MP10_160 Mod 6 White Rock Wind Farm (WRWF) - Further Information

This letter has been prepared by White Rock Wind Farm Pty Ltd (WRWFPL) in response to the Department's request for further information (RFI, email dated 21 November 2018), to address additional comments received from the Office of Environment and Heritage (OEH) and the Roads and Maritime Service (RMS).

1. OEH Request for Further Information (Letter dated 5 November 2018)

2. RMS Request for Further Information (Email dated 8 November 2018)

5.5 Km's: Industrial Drive onto Maitland Road at Mayfield West.

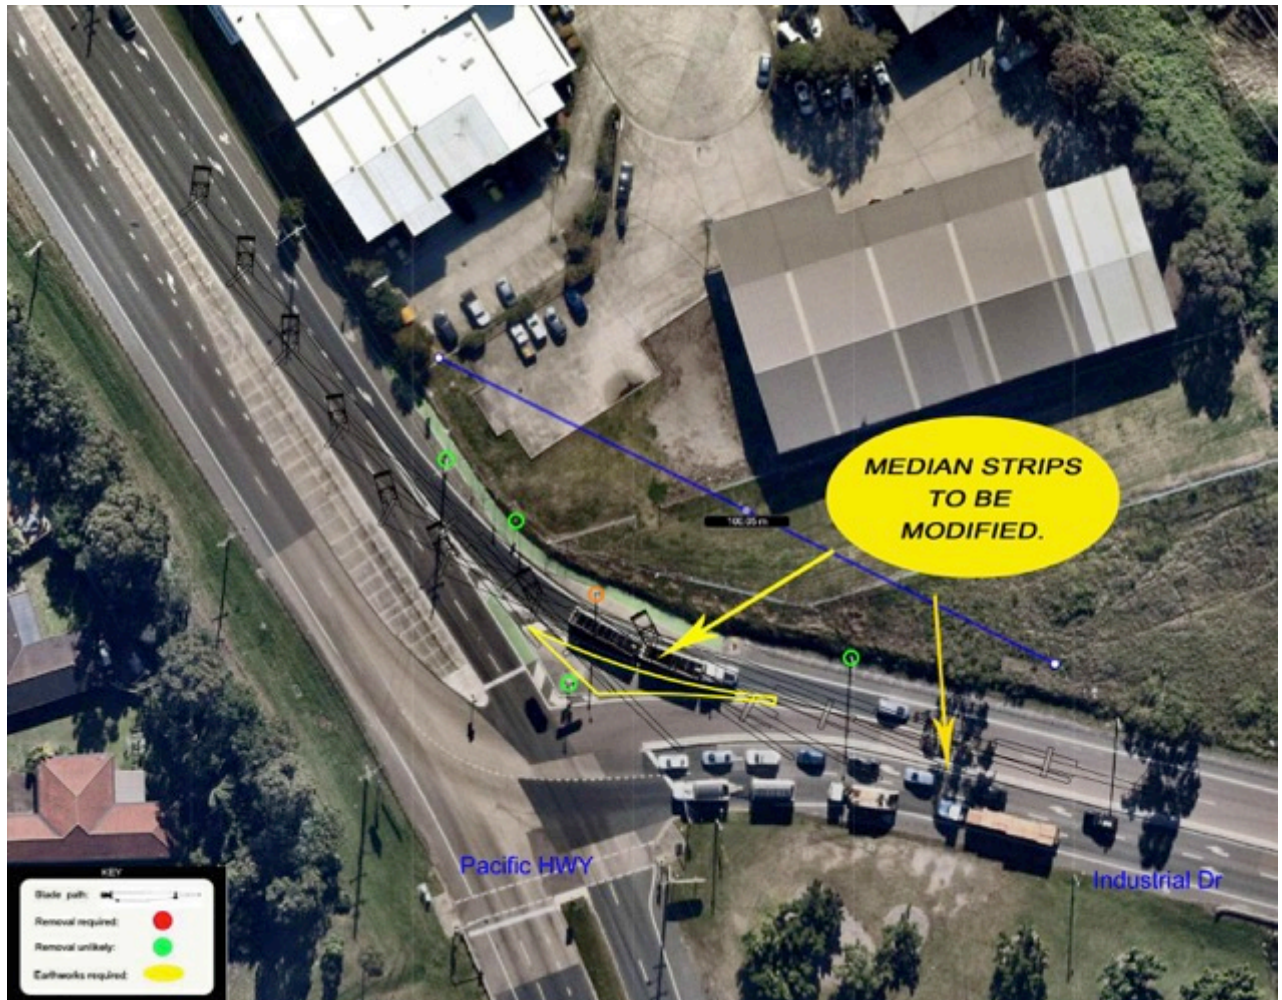
COMMENTS: The loads will need to cross to the incorrect side of the intersection, before crossing back over 200 metres to the north. The centre median strip will need to be modified so the trucks can cross over safely.

ROAD MODIFICATIONS: Yes moderate amounts of works are required.

67.3 Km's: New England Highway onto Golden Highway at Whittingham.

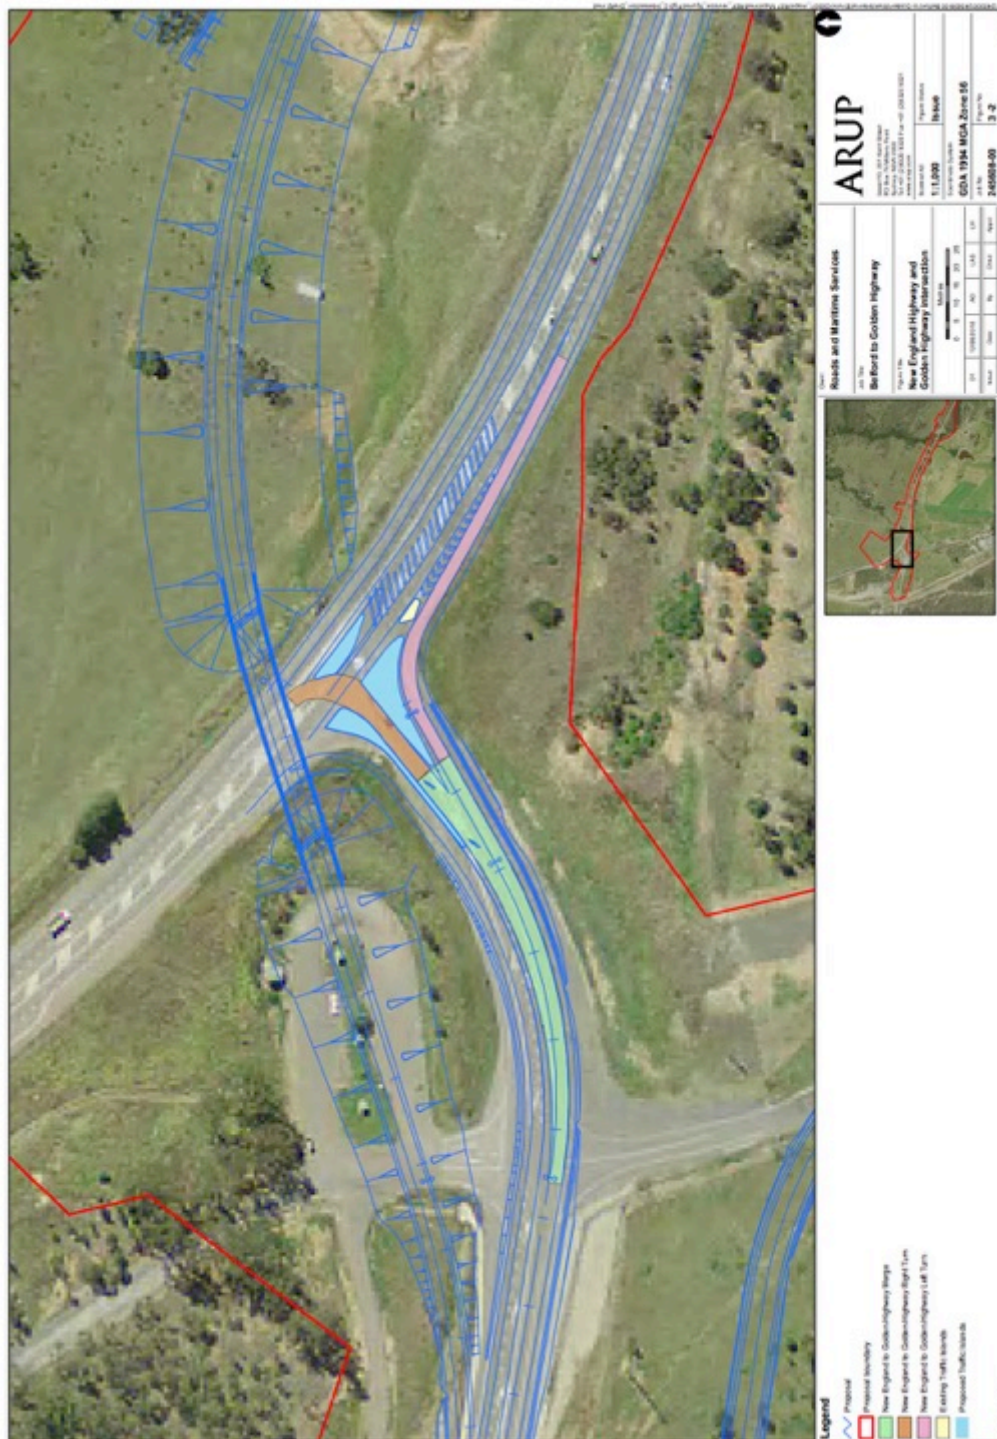
ROAD MODIFICATIONS: NOTE: This intersection is currently in line to be upgraded. The details on image 1 shows that the changes should not affect the swept path, however it is recommended that this is monitored.

80.8 Km's: Golden Highway intersection with Putty Road at Mount Thorley.

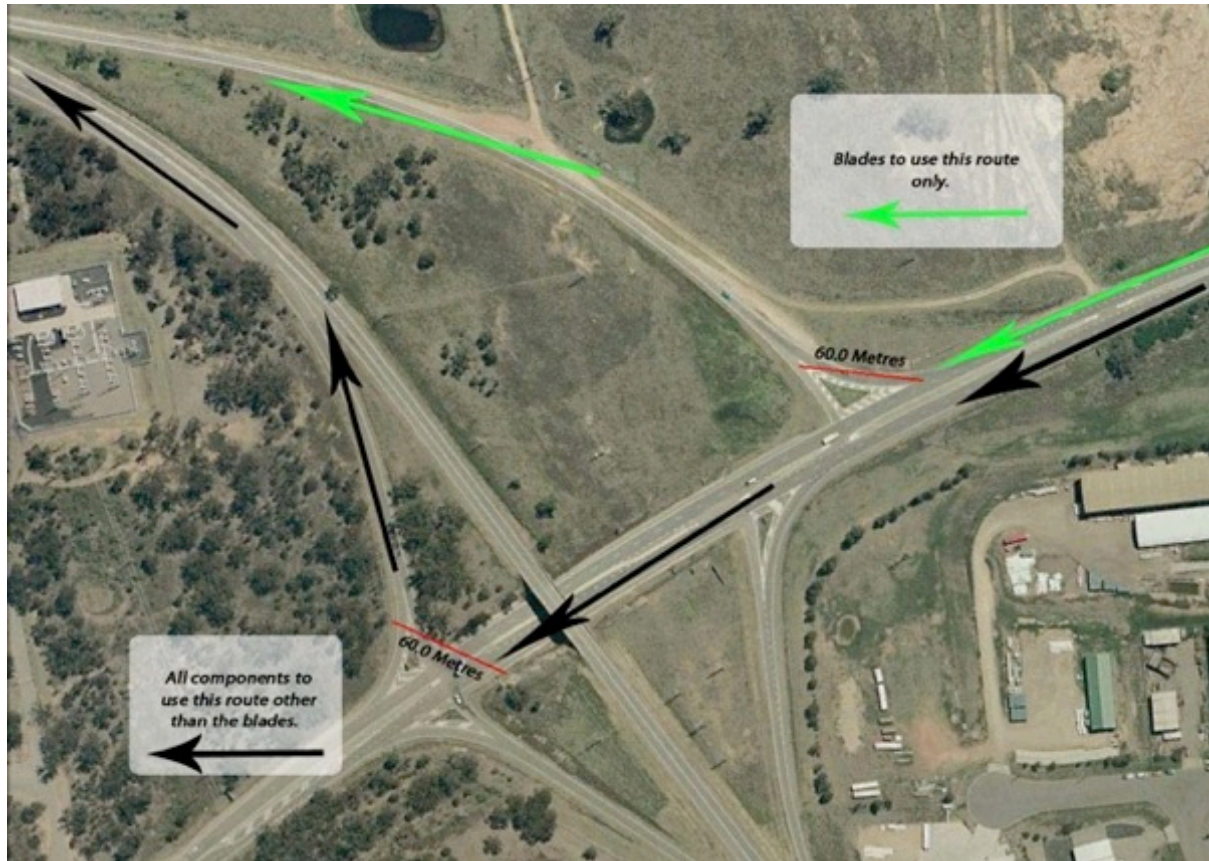
COMMENTS: Loads to turn from the incorrect side to the incorrect side. Blades to cross to the incorrect side prior to the intersection, and return to the correct side when the lanes remerge. Spotter to keep the driver informed throughout the procedure.

NOTE: Towers and general loads will travel under the overpass and stay on the correct side of the road. The overpass is 5.6 in the center of the road. Loads that exceed 5.6 high will need to take the blade detour.

ROAD MODIFICATIONS: No works required.

107.0 Km's: Golden Highway through Jerrys Plains.

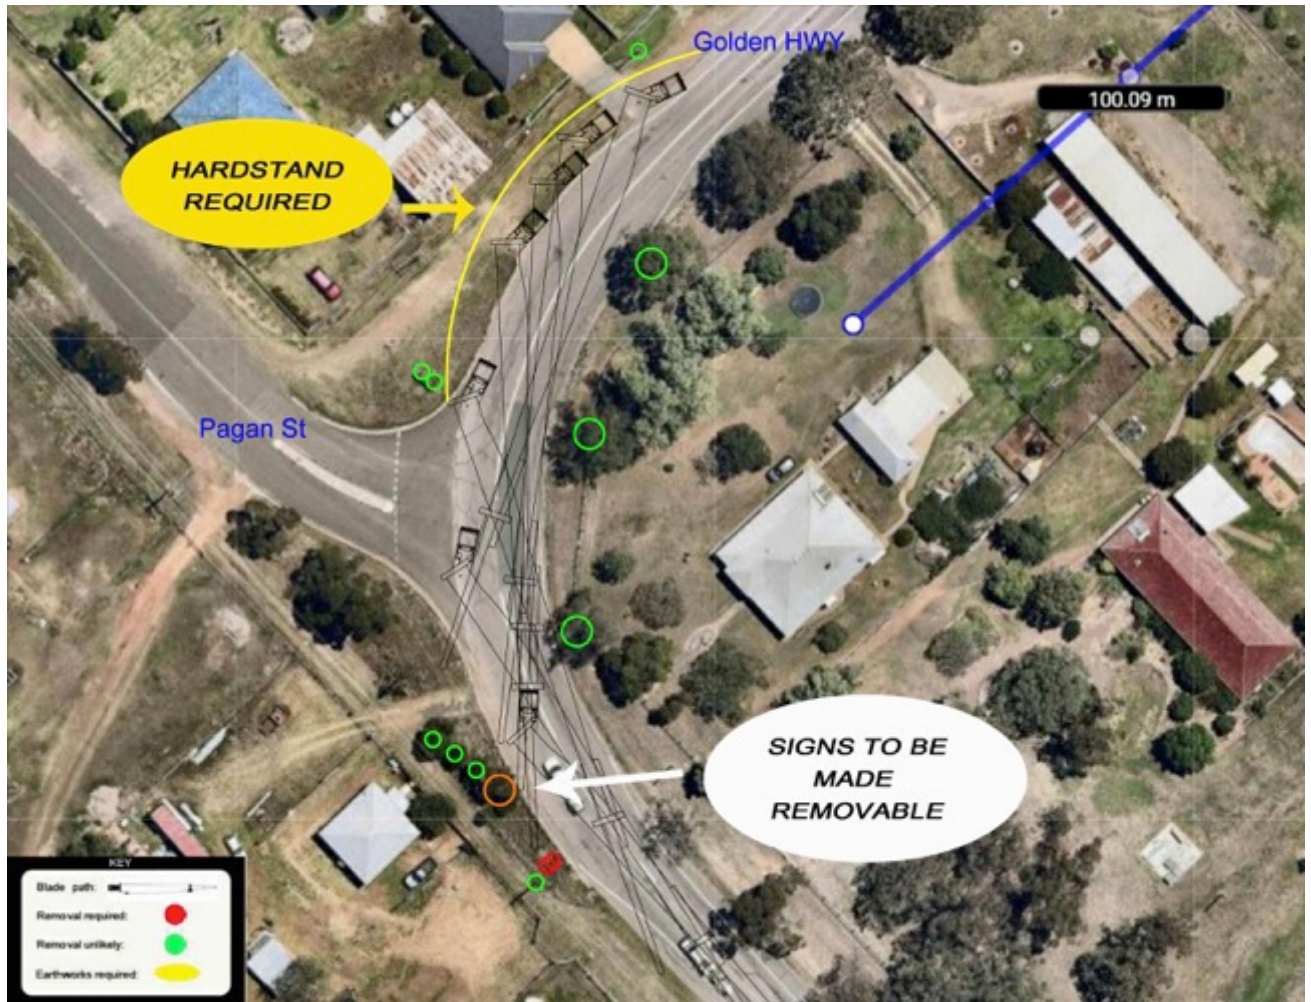
COMMENTS: Blades to cross from the incorrect side to the incorrect side. Some signs will need to be made removable and some hardstand added, additionally some trees will need to be trimmed/removed. Police and escorts to control local traffic either side of the intersection.

ROAD MODIFICATIONS: Moderate amounts of work are required.

141.9 Km's: Golden Highway intersection with Denman Road at Denman.

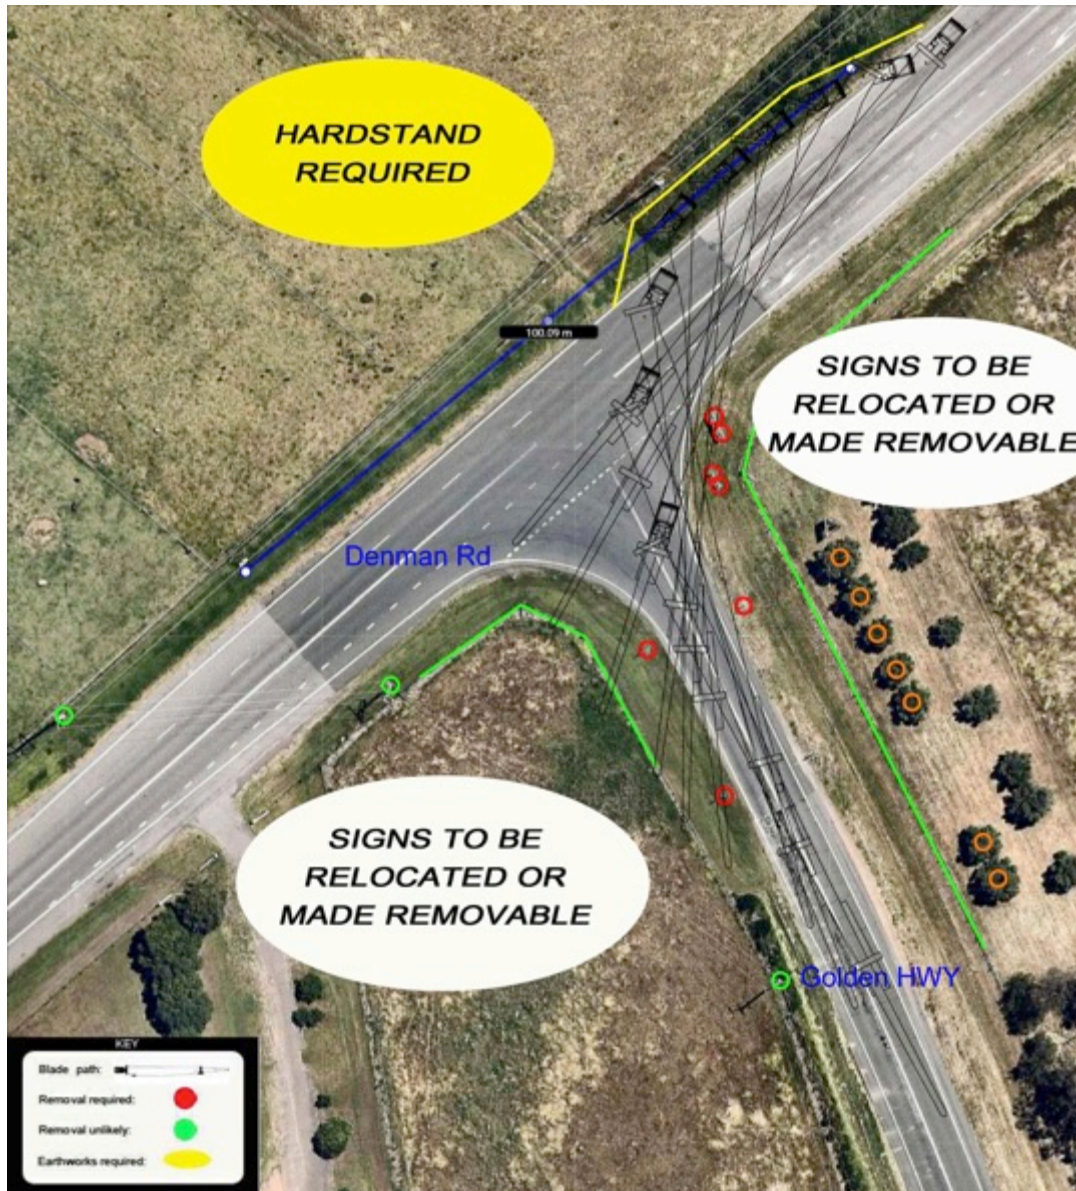
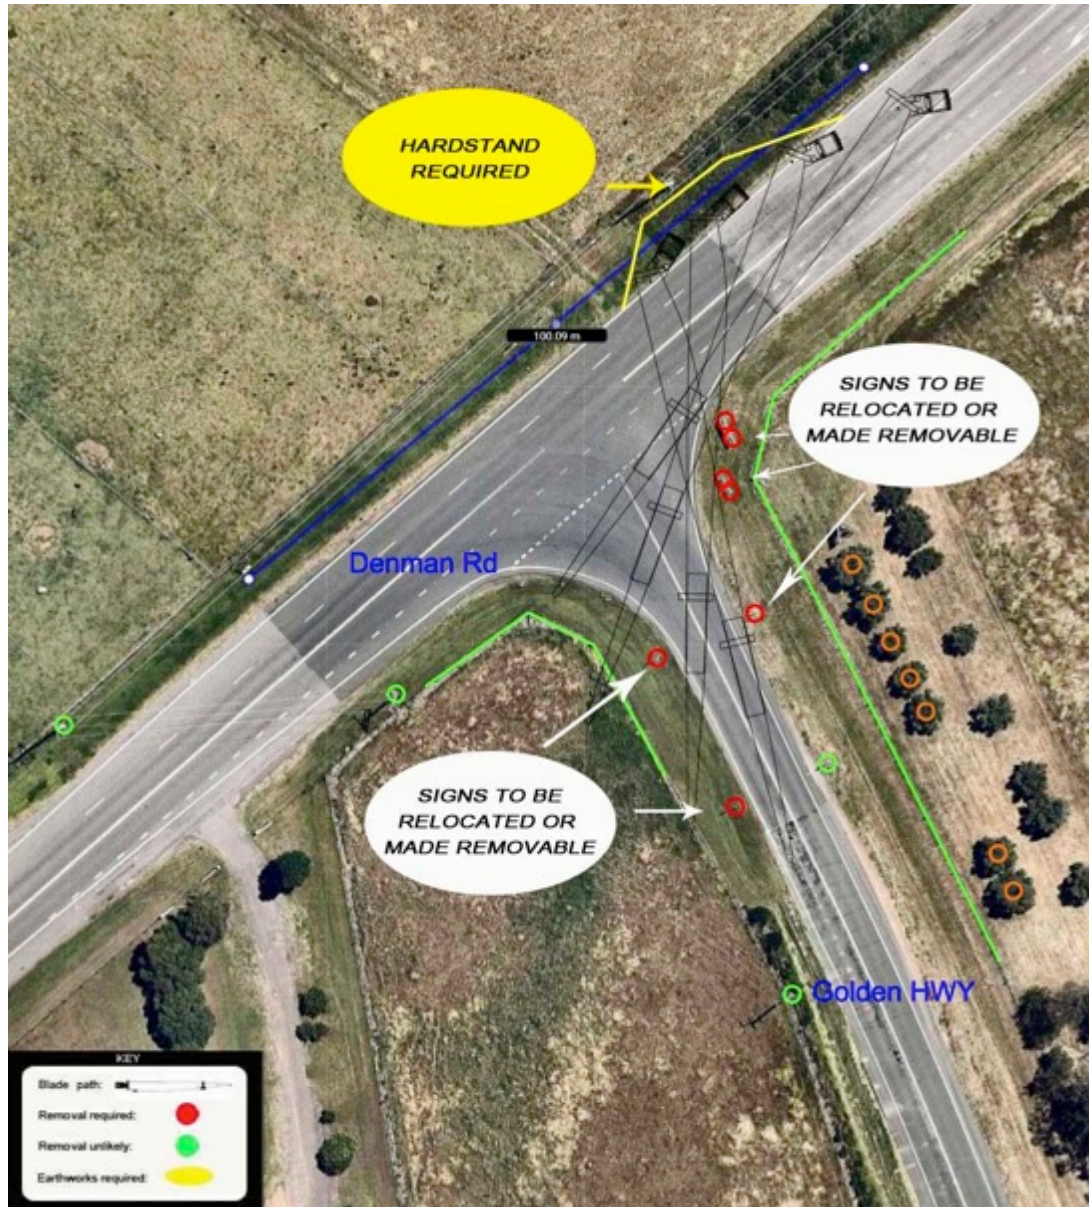
COMMENTS: Blades to cross from the correct side to the correct side. Some signs will need to be made removable and some hardstand added to the outside of both turns. Police and escorts to control local traffic either side of the intersection.

COMMENTS: Blades to cross from the correct side to the correct side. Some signs will need to be made removable and some hardstand added to the outside exit to the corner. Police and escorts to control local traffic either side of the intersection.

ROAD MODIFICATIONS: Moderate amounts of work are required.

ROAD MODIFICATIONS: Moderate amounts of work are required.

149.0 Km's: Denman Road onto Bengalla Road at Muswellbrook.

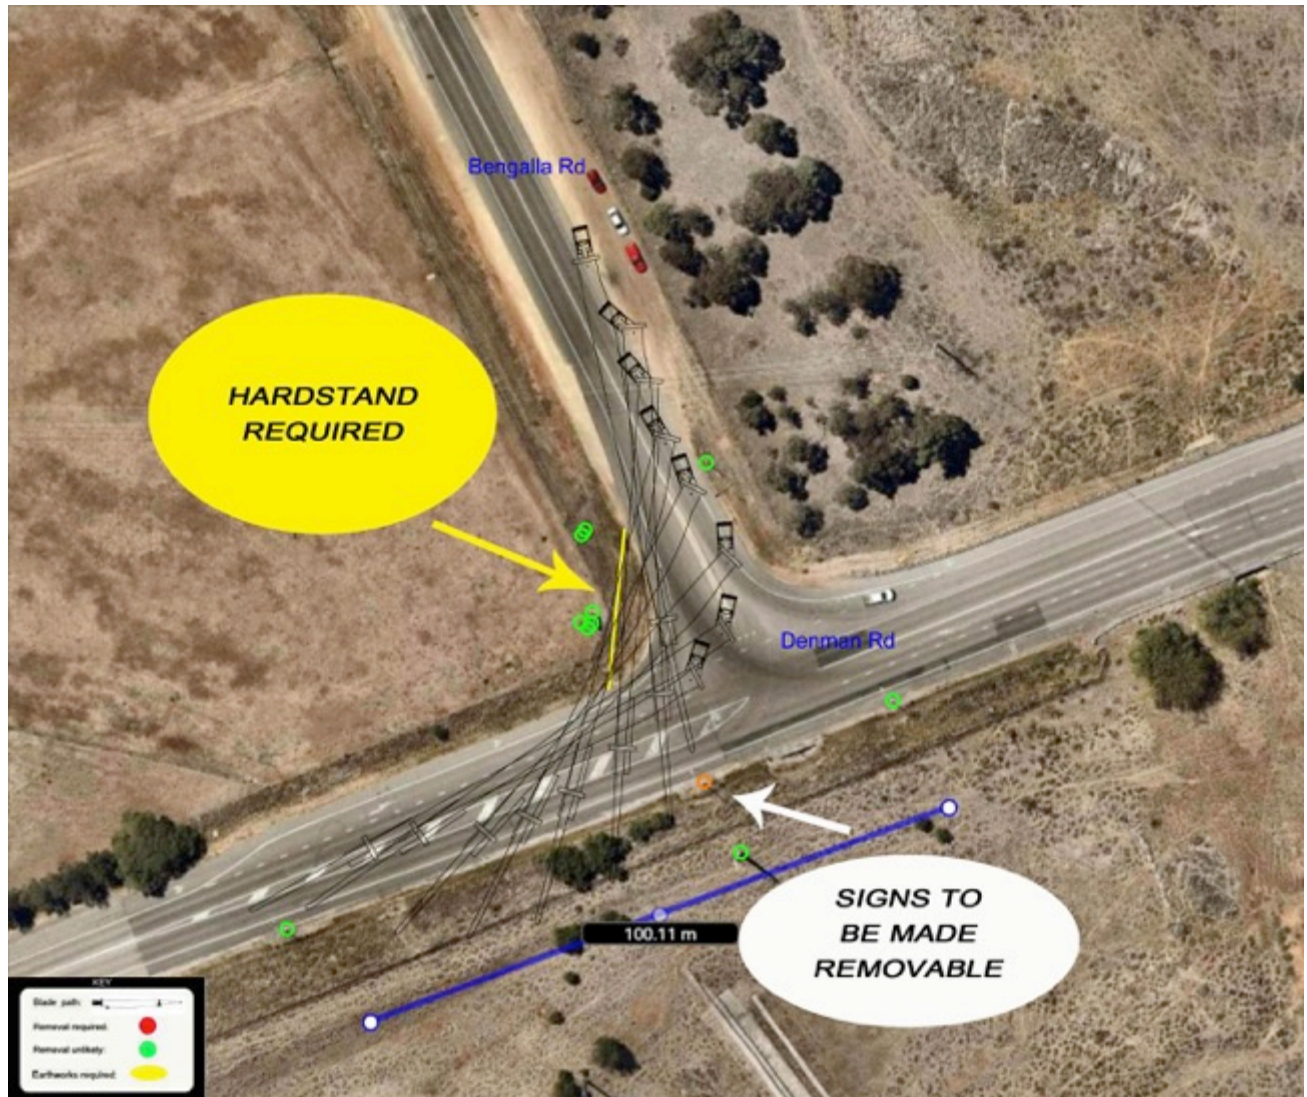
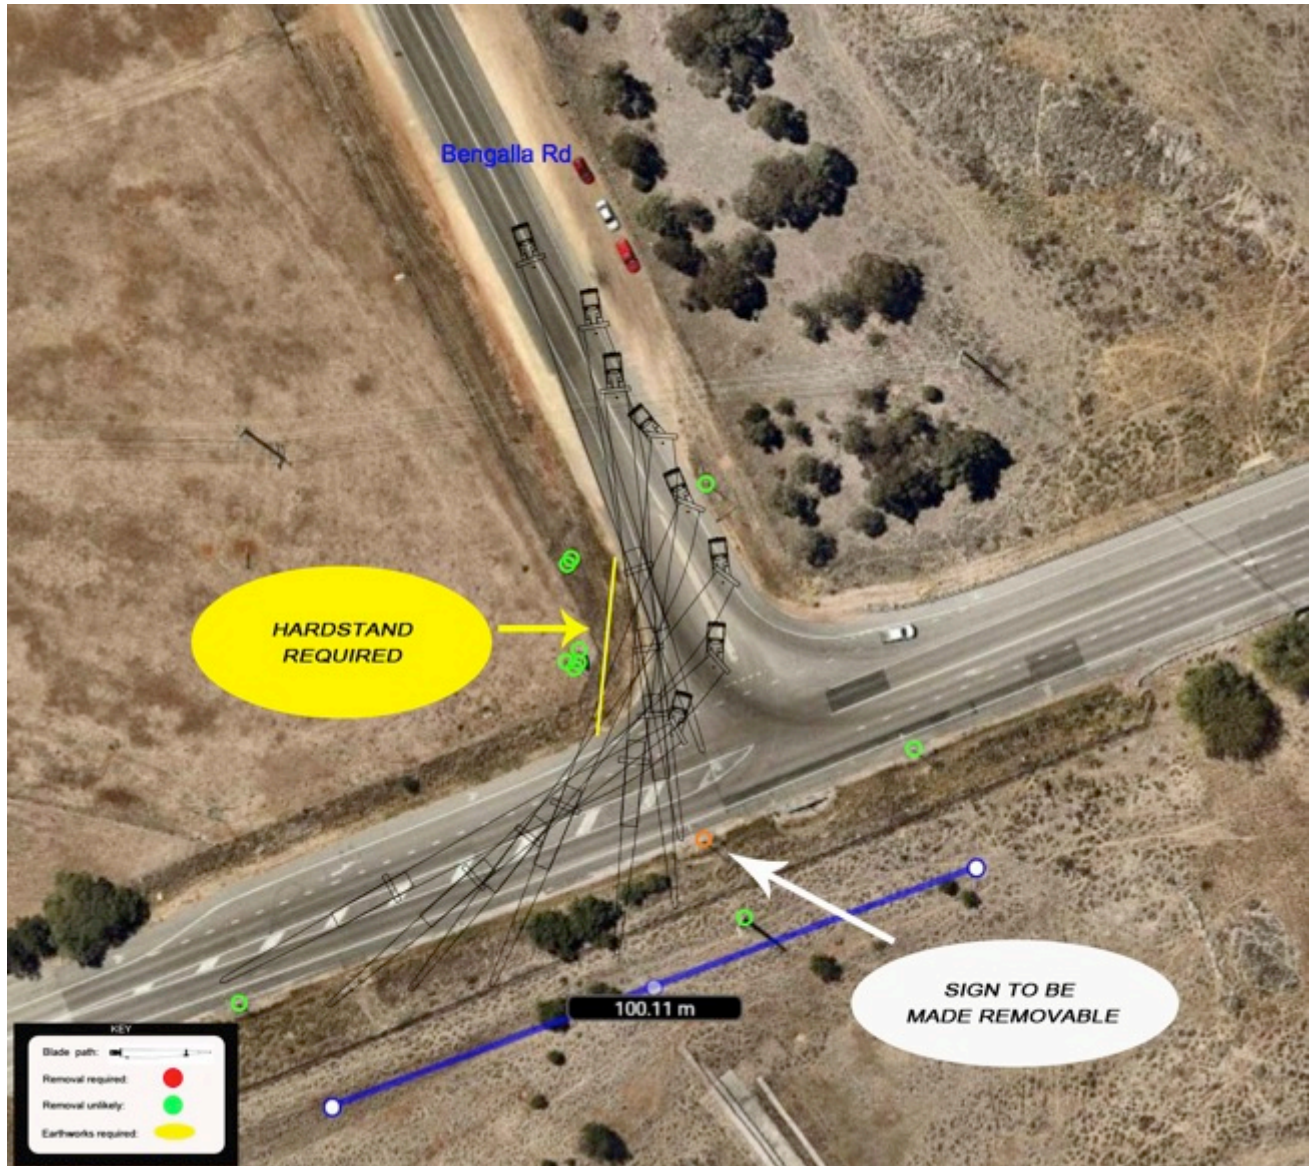
COMMENTS: Blades to cross from the incorrect side to the incorrect side. Some signs will need to be made removable and some hardstand added to the inside of the corner. Police and escorts to control local traffic either side of the intersection.

COMMENTS: Blades to cross from the incorrect side to the incorrect side. Some signs will need to be made removable and some hardstand added to the inside of the corner. Police and escorts to control local traffic either side of the intersection.

ROAD MODIFICATIONS: Moderate amounts of work are required.

ROAD MODIFICATIONS: Moderate amounts of work are required.
